SUBJECT: Class II Permissive Charge for FCC ID: 2ADSH-V3BT

The product, Electronic door lock V3, has been granted by FCC dated 07/31/2017, FCC ID: 2ADSH-V3BT. Now we, Danalock Aps, would like to modify the authorized equipment for below changes:

Changes to PCB 101-025_D1 to 101-025_H1

Rotation sensor:

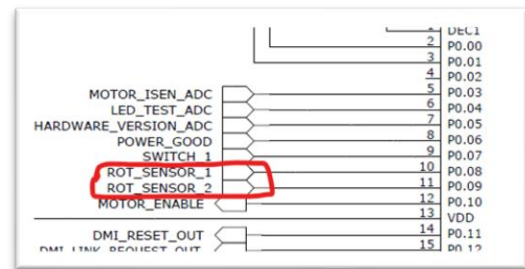
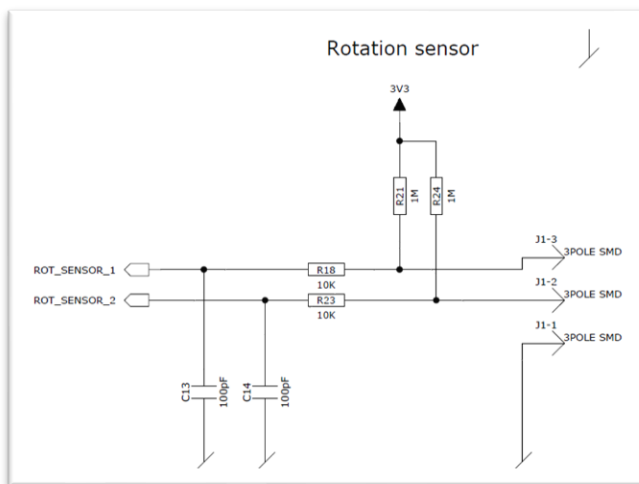
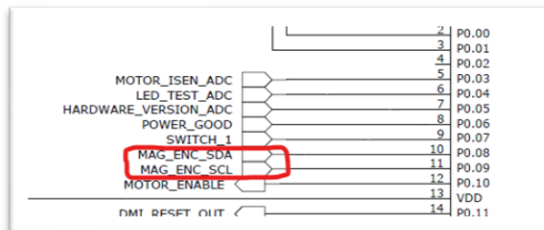
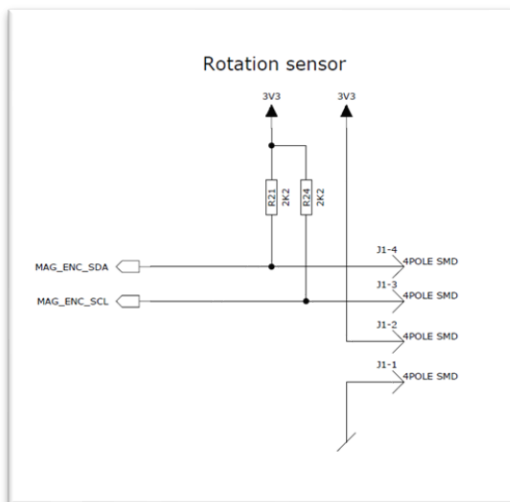
- - Changed the name and address of the applicant;
- - Changed the name and address of the manufacture;
- - Changed the hardware version;
- - Changed the software version;
- - Fuse added;
- - New DC motor;
- - PCB layout and component placement;
- - A magnetic sensor PCB (227181) and magnetic sensor chip (The new H1 lock uses magnetic sensing for open/close instead of the electrical sensor in the D1 design).
- Based on the above changes, only reevaluates Radiated Spurious Emissions..

New 101-025_H1:
